Agenda Item #1

Application 2025-42-CA

Remove existing windows on west elevation and replace with vinyl windows

Summary of Analysis:

WEST DEMOLITION ELEVATION
 SCALE: 3/16"=1'-0"

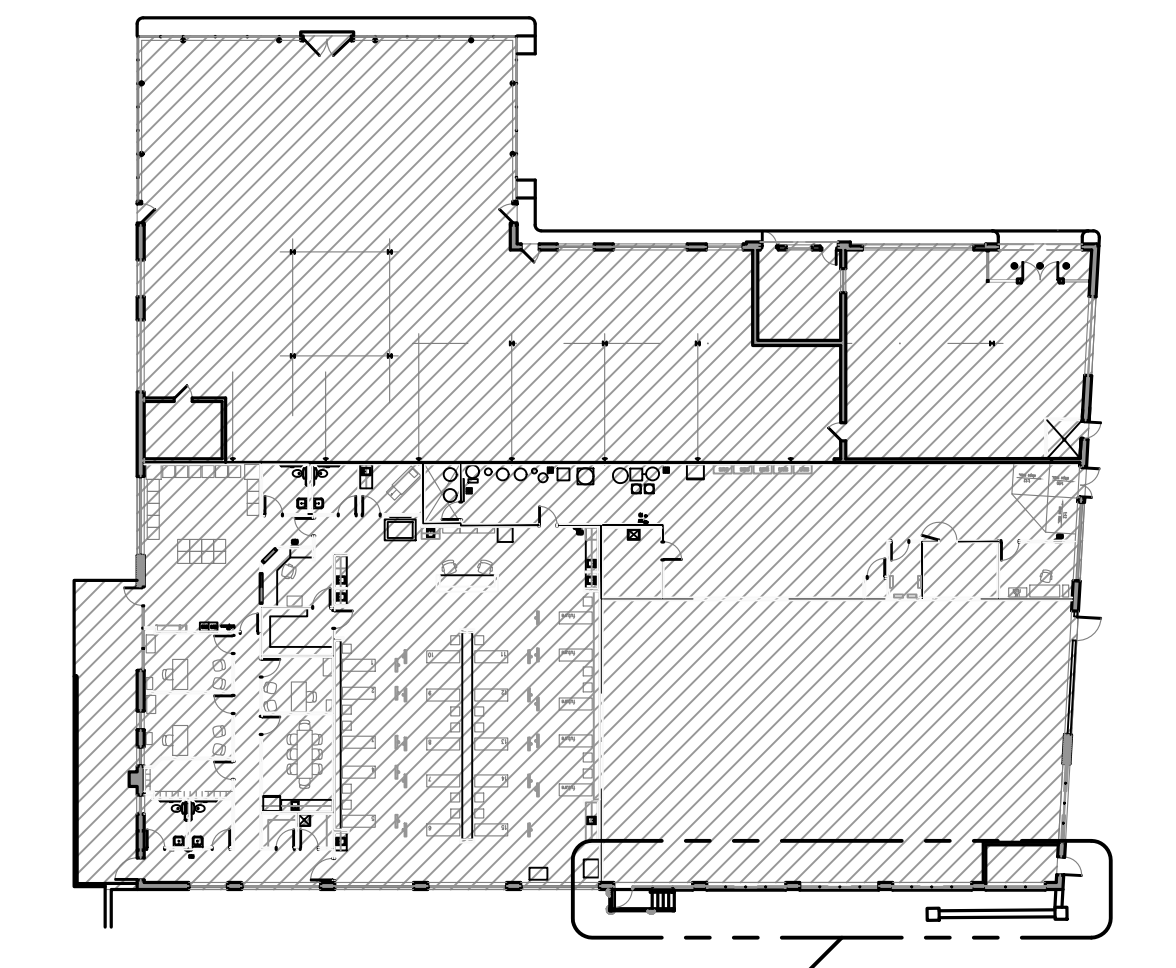
- NOTES:**
- EXISTING WINDOWS TO BE REMOVED TO PREPARE FOR NEW BLIND WINDOWS.
 - EXISTING WINDOW "T" FRAMING TO REMAIN TO PREPARE FOR NEW BLIND WINDOW, TYP. (5) ON THE WEST SIDE OF BUILDING.
 - G.C. TO VERIFY ALL DIMENSIONS PRIOR TO CONSTRUCTION
